## OJAI UNIFIED SCHOOL DISTRICT

**BID ADDENDUM NO. 1**      ISSUED 3/18/2019

#### REPAINTING PROJECT AT VARIOUS CAMPUSES

MATILIJA JUNIOR HIGH SCHOOL PROJECT NO. 2019-1608  
MEINERS OAKS ELEMENTARY SCHOOL PROJECT NO. 2019-1110  
MIRA MONTE ELEMENTARY SCHOOL PROJECT NO. 2019-1205  
NORDHOFF HIGH SCHOOL PROJECT NO. 2019-1713  
TOPA TOPA ELEMENTARY SCHOOL PROJECT NO. 2019-1507

**SITE PLAN**

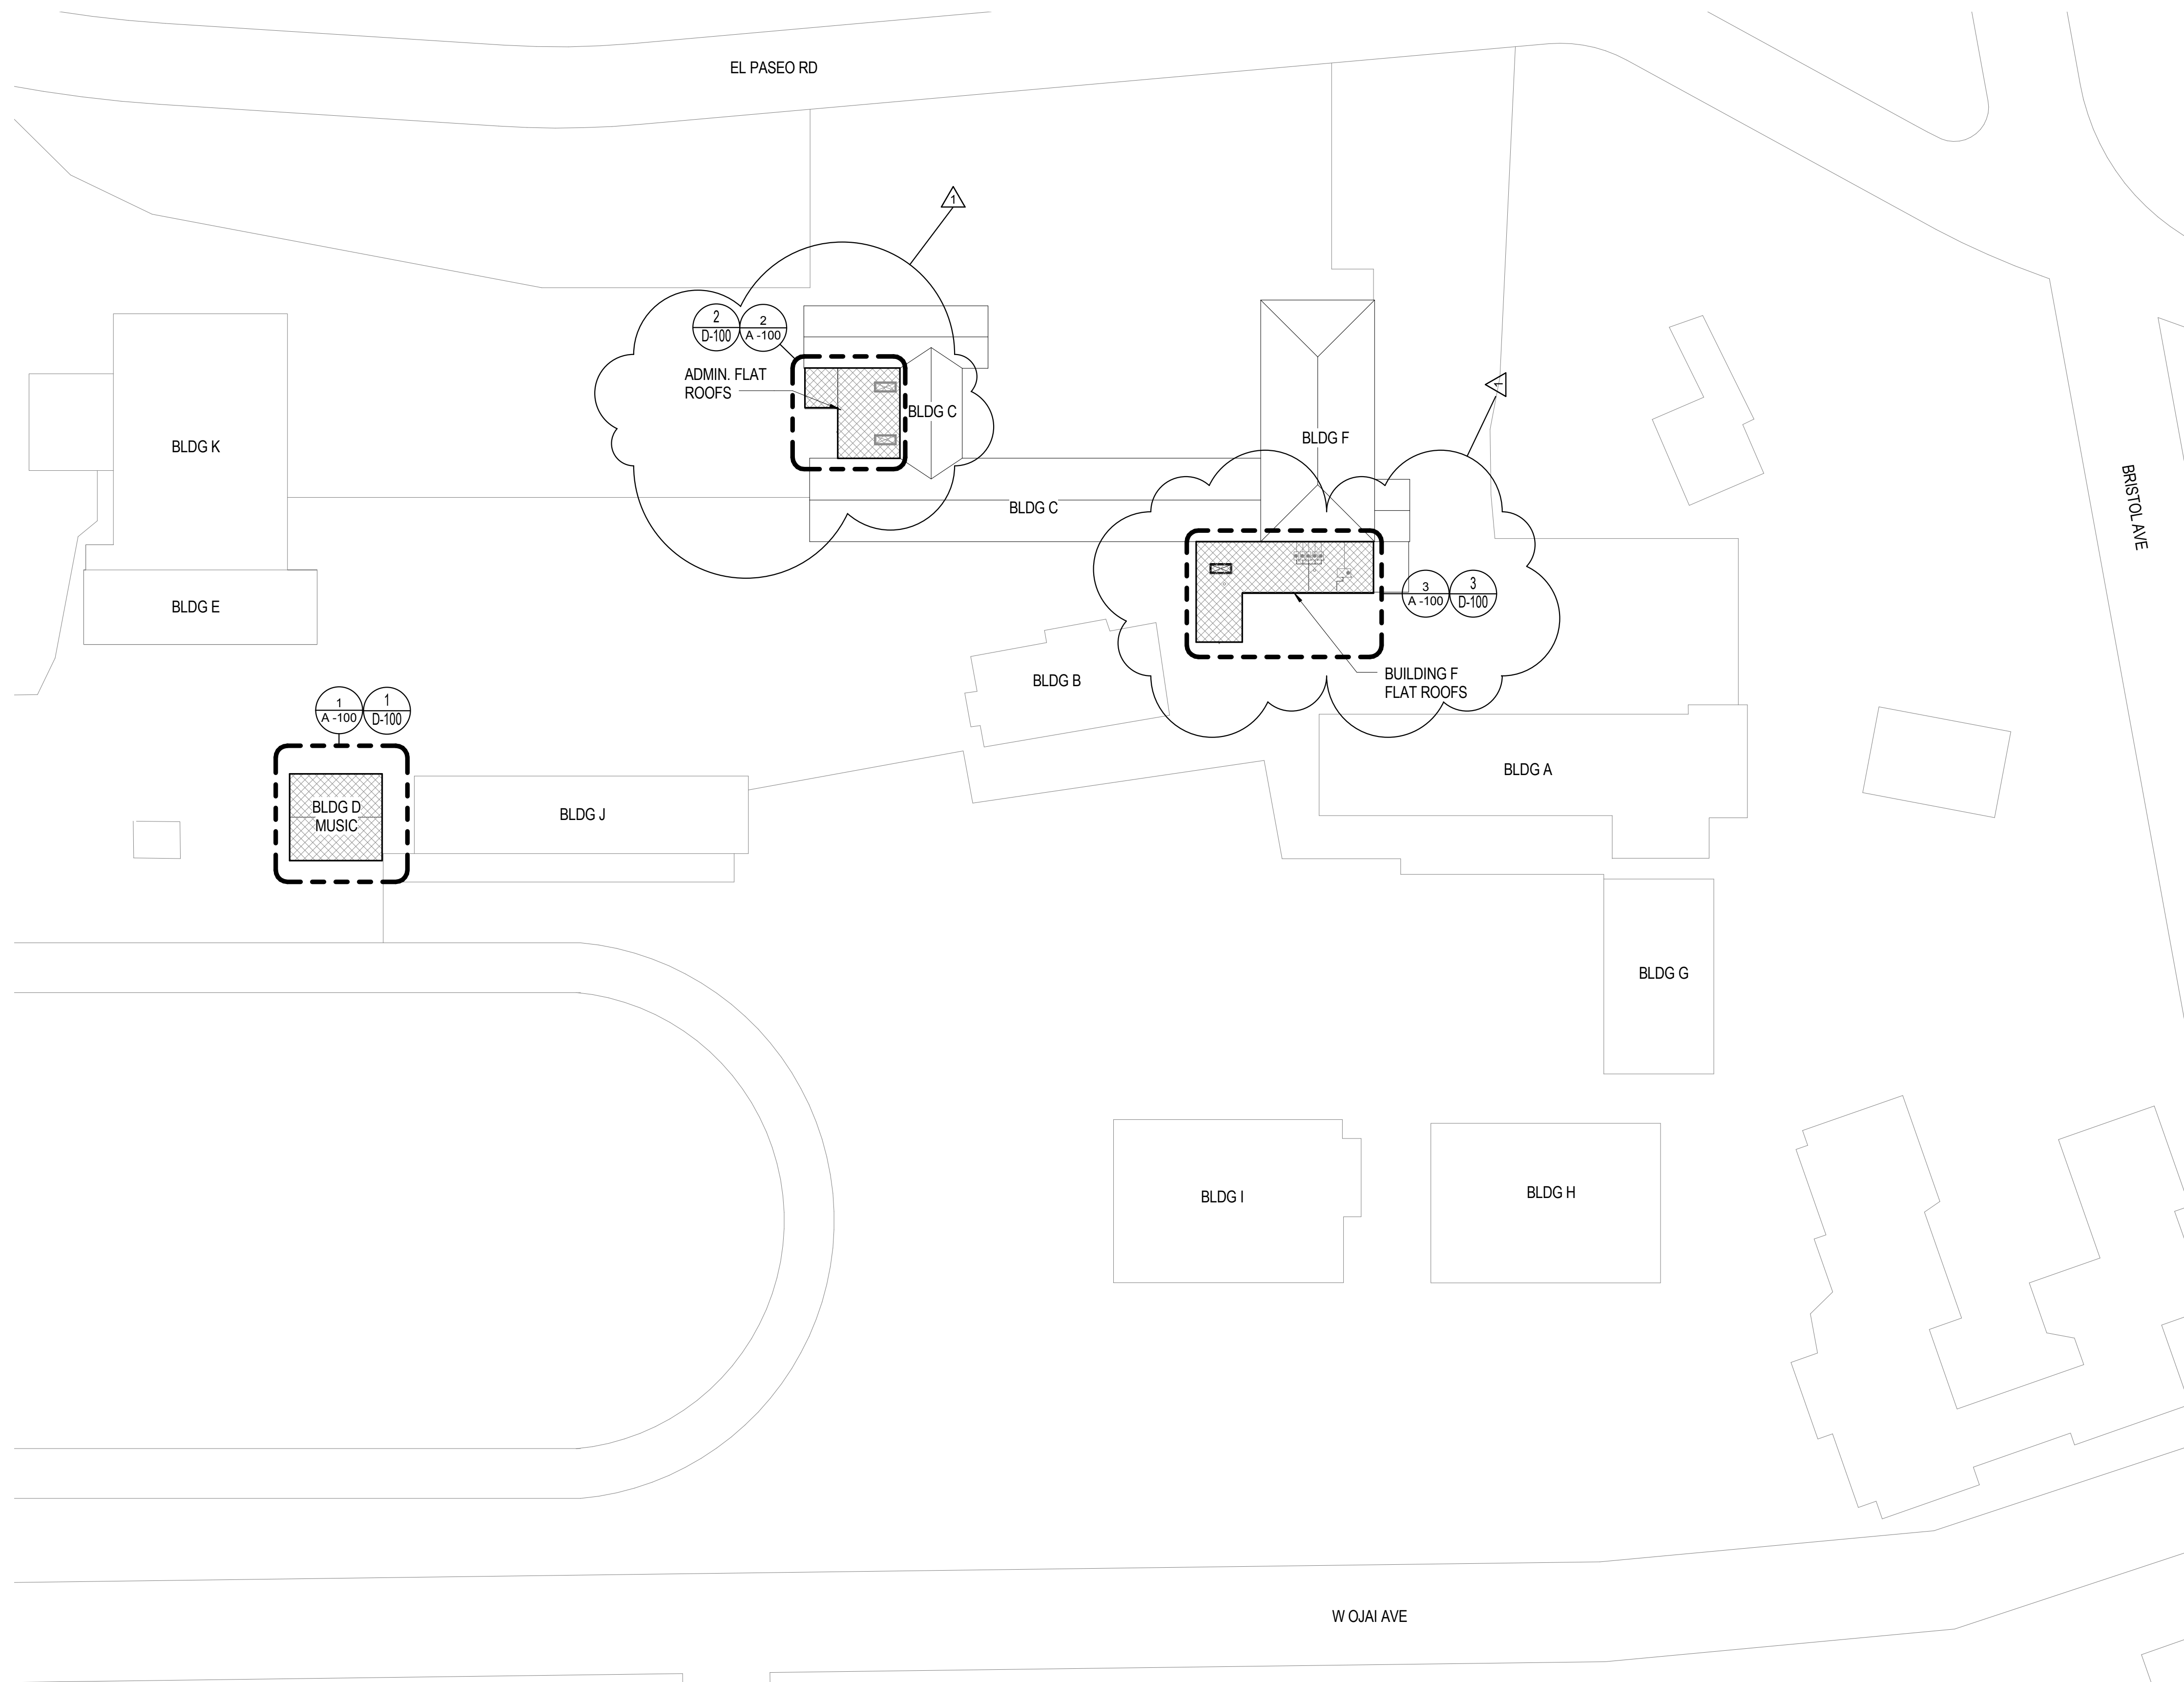
Item 2 Revise drawings to revise the roof restorations to be roof replacements. Revised Drawings:

**BLDG F - ROOF PLAN**

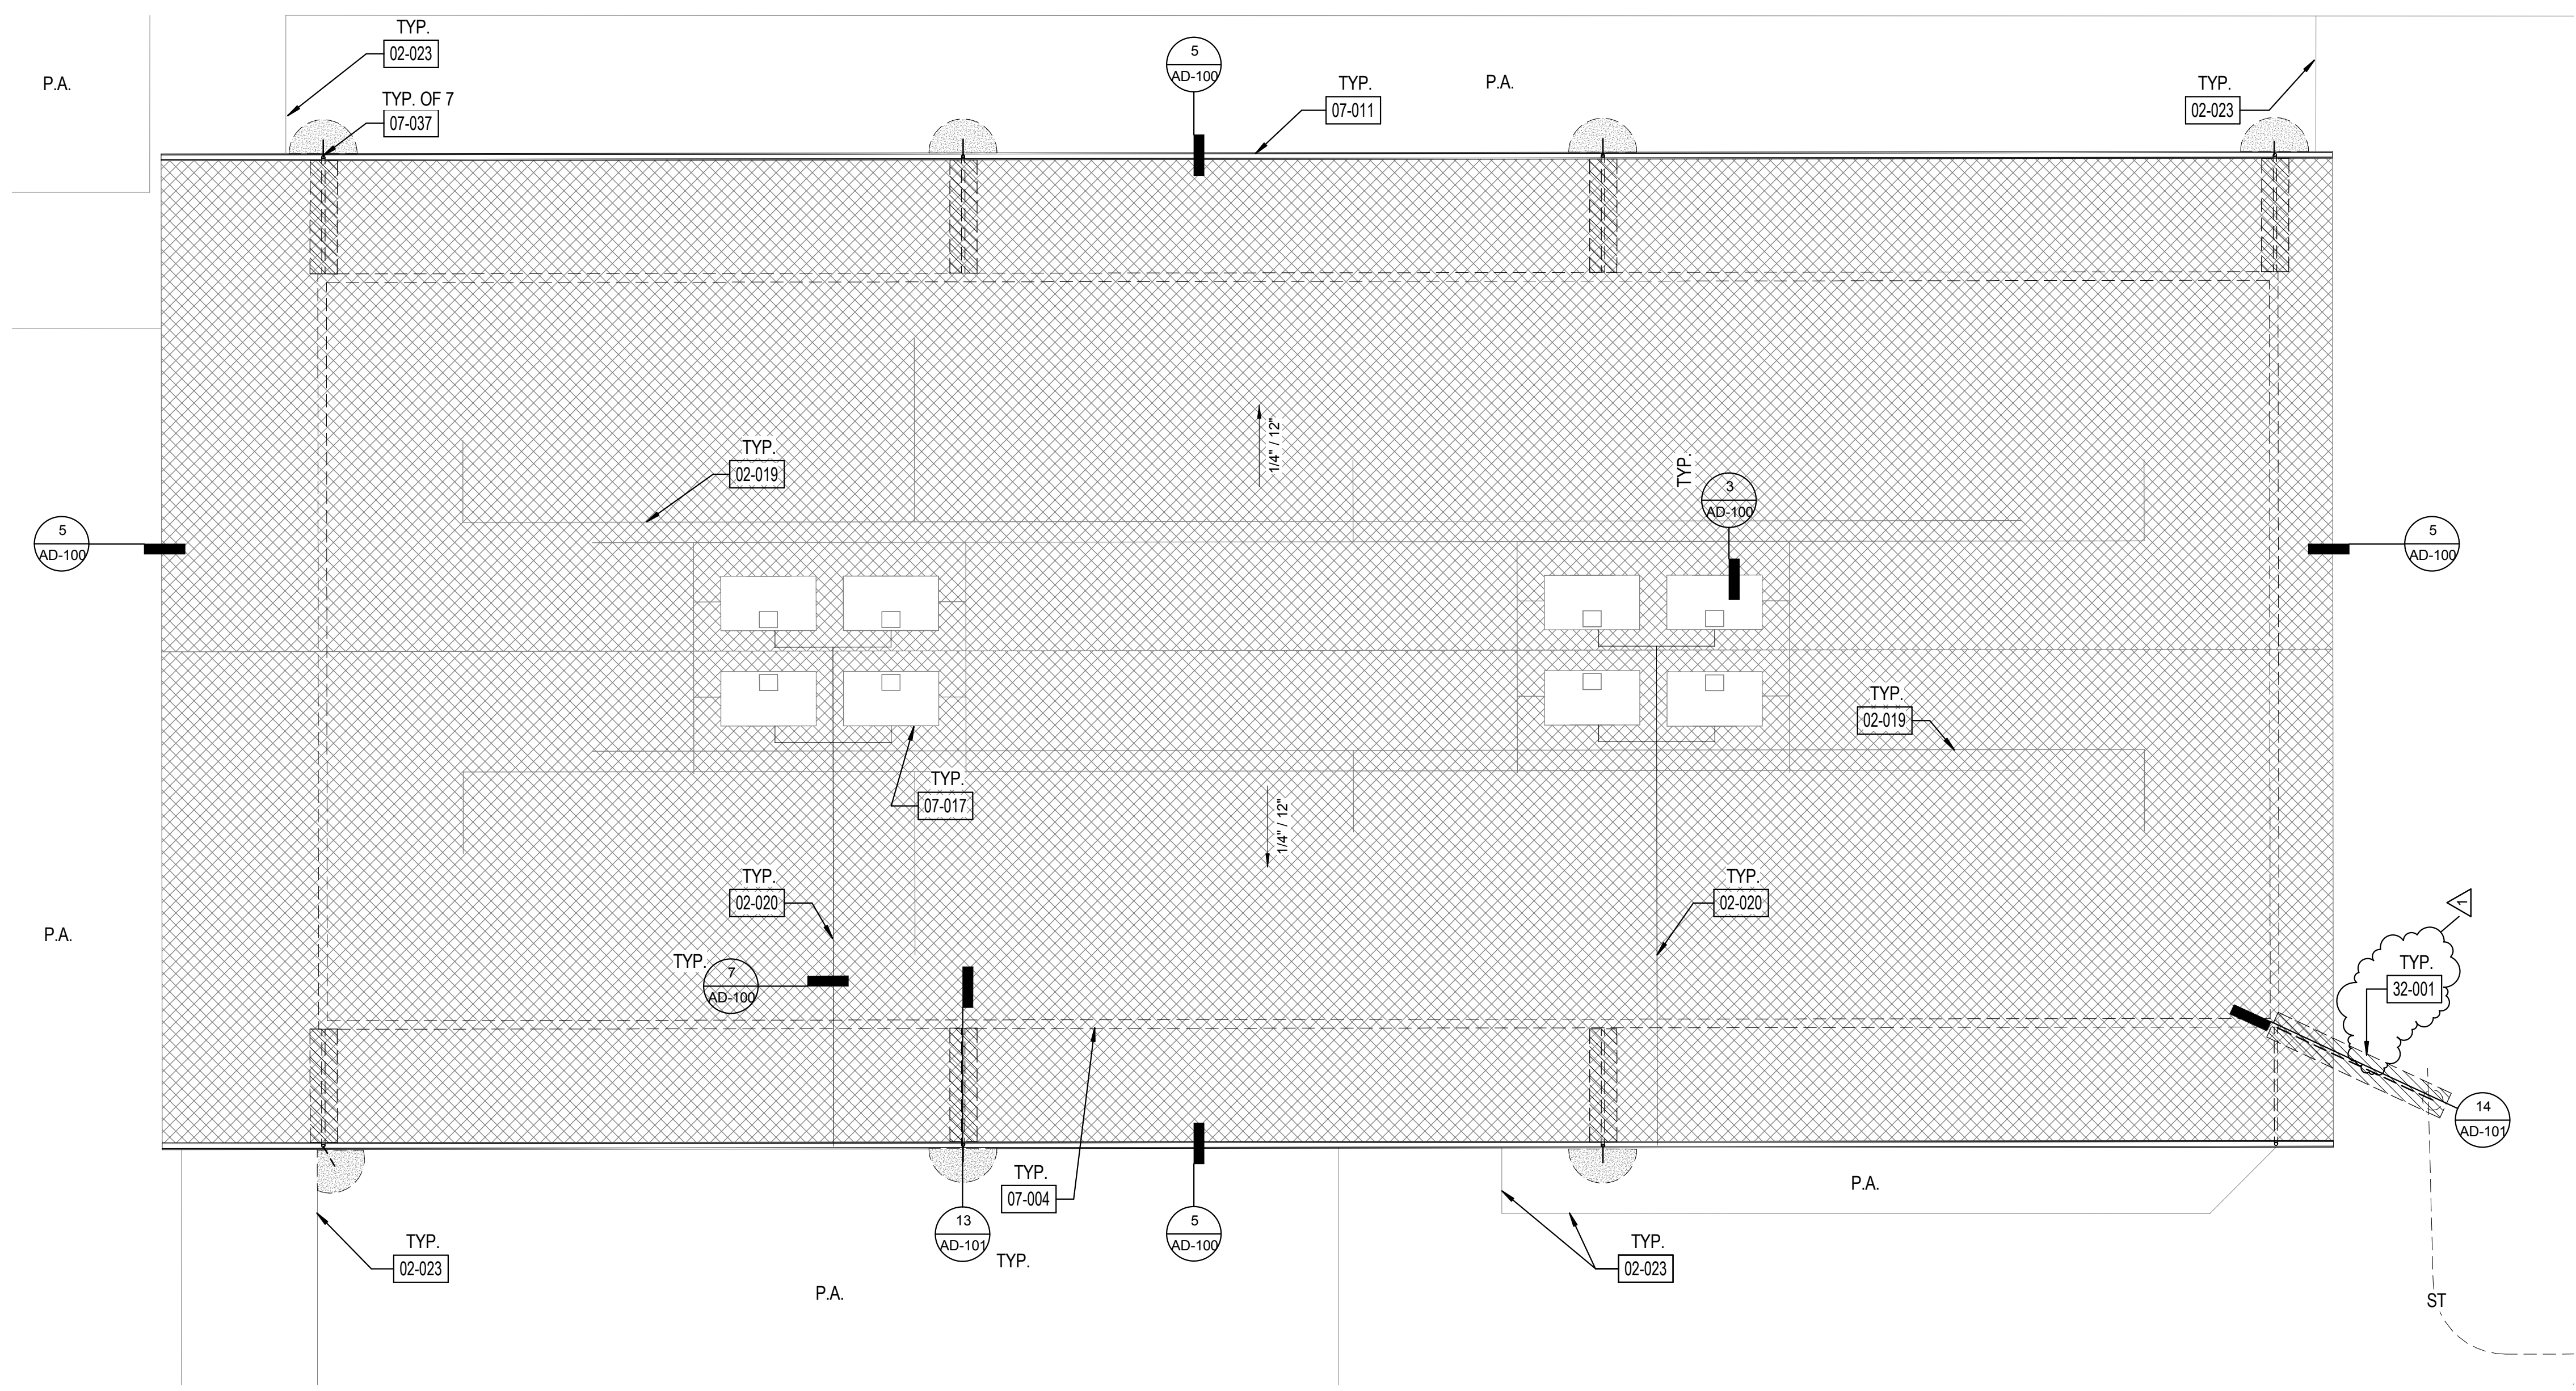
- Item 4 Concrete and storm drain connections revised to be Bid Alternate (optional).  
Revised Drawings:  
G-000 Title Sheet  
A-101 Building I & J Roof Plans  
A-102 Building F Roof Plan
- Item 5 Revisions to extent of gravel  
A-102 Building F Roof Plan

- BID ALT 01:** DEMOLISH (E) 4" CONC. WALK FOR DOWNSPOUT LINE AND PATCH TO MATCH EXISTING.
- CLASS A MODIFIED BITUMEN ROOFING OVER (E) DECKING. REFER TO 11/AD-100 FOR ASSEMBLY.
- P.A. PLANTER AREA
- (E) EXHAUST FAN
- (E) VENT PIPE THROUGH ROOF
- (E) SKYLIGHT
- ROOF VENT
- (E) WALL BELOW
- BID ALT 01:** DOWNSPOUT CONNECTION TO (E) STORM DRAIN, REFER TO 13/AD-101
- BID ALT 01:** DOWNSPOUT TO (E) LANDSCAPE/GRAVEL, REFER TO 13/AD-101
- (E) STORM DRAIN LINE, U.O.N.

**BLDG A -  
 ROOF PLAN**

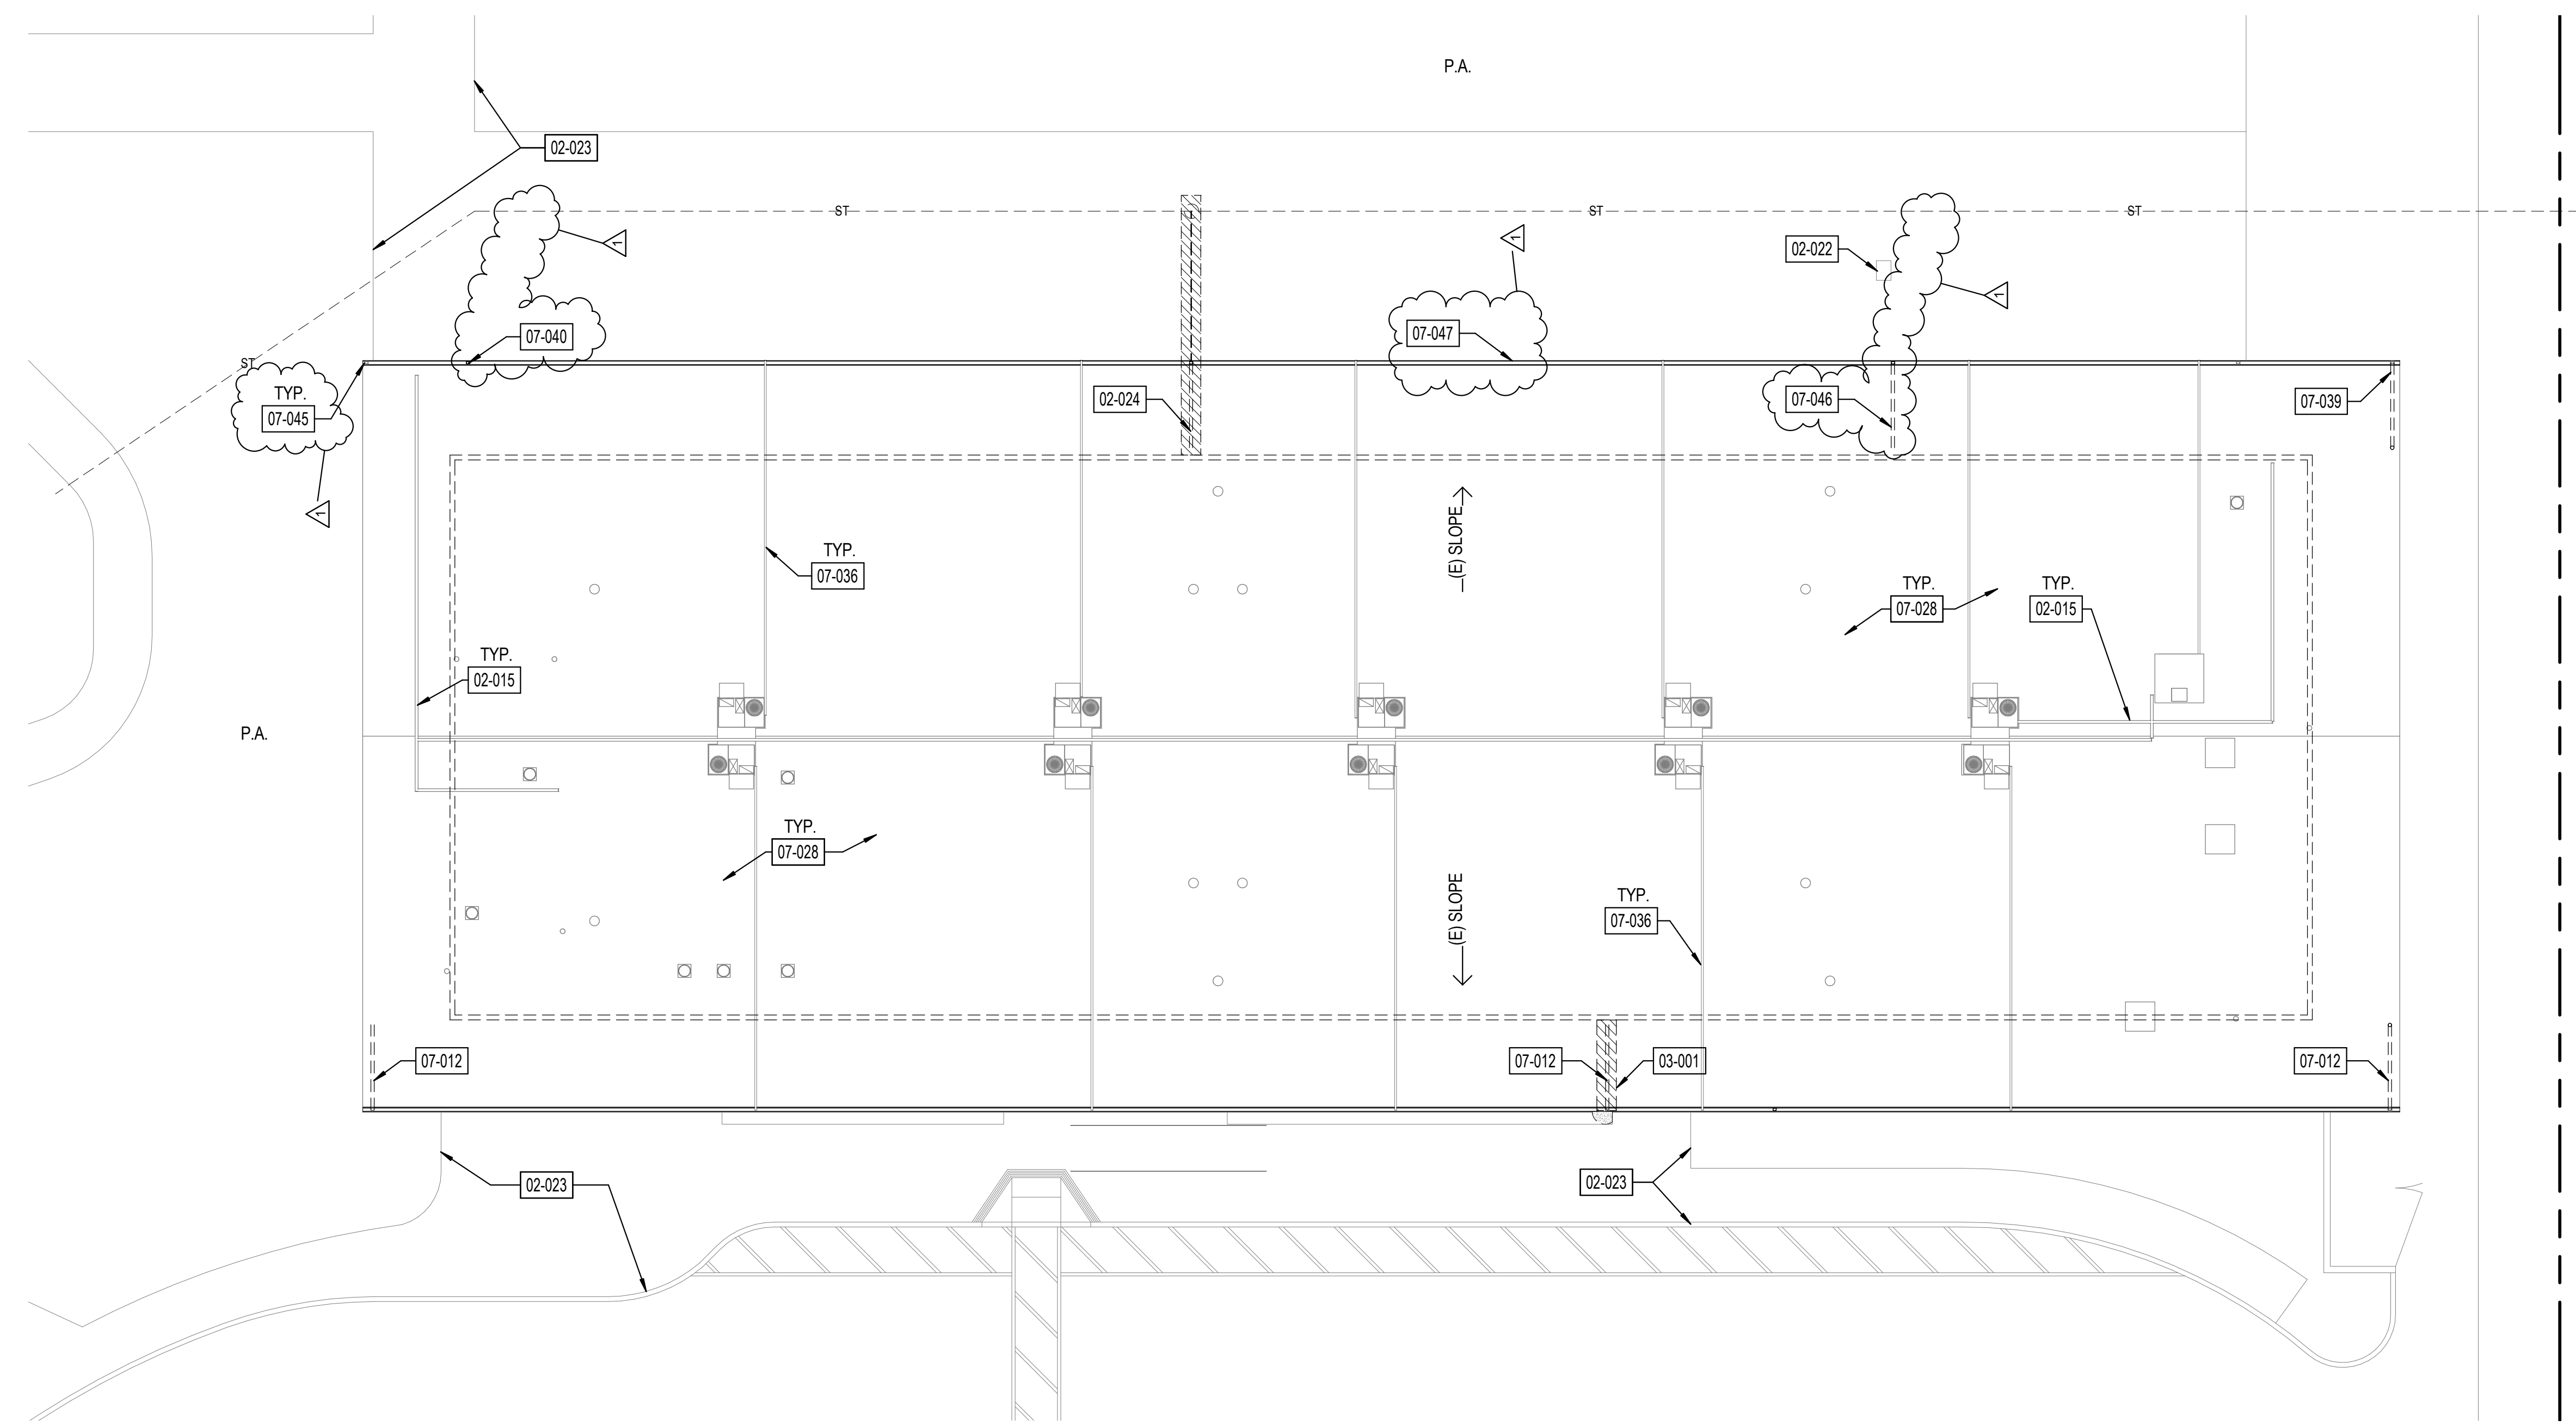
- Item 6 Concrete and storm drain connections revised to be Bid Alternate (optional).  
Revised Drawings:  
G-000 Title Sheet  
A-101 Building A Roof Plan
- Item 7 Scope of gutter and downspout work revised  
A-101 Building A Roof Plan  
AD-101 Roof Details

- 02-015 PROTECT IN PLACE (E) UTILITY LINE
- 02-022 PROTECT IN PLACE (E) GAS VAULTS
- 02-023 PROTECT IN PLACE (E) CONC. WALK
- 02-024 (E) DOWNSPOUT, MAKE NEW CONNECTION TO (E) STORM DRAIN LINE
- 03-001 DEMOLISH (E) 4" CONC. WALK FOR DOWNSPOUT LINE AND PATCH TO MATCH EXISTING.
- 07-012 PROTECT IN PLACE (E) GUTTER AND (E) DOWNSPOUT
- 07-028 PROTECT IN PLACE (E) ROOF
- 07-036 REPLACE DURA-BLOCK EQUIPMENT SUPPORT W/ OMG PIPEGUARD PIPE SUPPORT MINI.
- 07-039 INSTALL NEW GUTTER & DOWNSPOUT, REFERENCE PIPE ATTACHMENT DETAIL.
- 07-040 DOWNSPOUT DOWN (E) SQUARE TUBE COLUMN. SIM. ROUND PIPE COLUMN DETAIL.
- 07-045 REPAIR (E) HOLE IN GUTTER.
- 07-046 UNINSTALL (E) DOWNSPOUT, REPAIR (E) HOLE IN GUTTER.
- 07-047 REVISE PITCH OF GUTTER.
